MEQI-63 Series and Accessories LC

Design Change Notification

BC
馬達直結

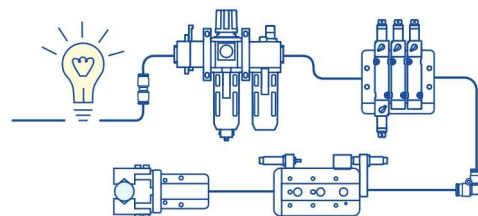
Design optimization. Unify all product lengths with different BC motor types. Unify LC accessory construction.

代號 規格	A	B1	B2	C	E	G	H	I	J	K	L1	L2	O	R	S	X	Y	ZB	ZC	ZT
63	32	17	24	37	M16×1.5	30	45	19	4	35	4.5	18	56.5	8	M8×1.25	77	77	162	64.0	263.0

LC

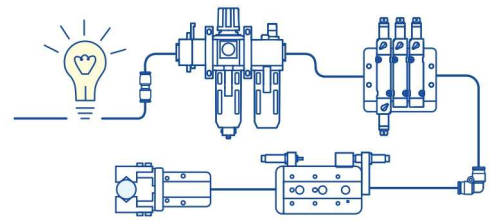
- It will not affect the usage of finished product, and will replace sequentially.
- Accessories **LC** will be replaced with new construction from now on.

代號 規格	A	E	LB	LH	LR	LS	LT	LX	LY	ZT
63	32	M16×1.5	9	50	92	110	12.5	88.5	176.5	231
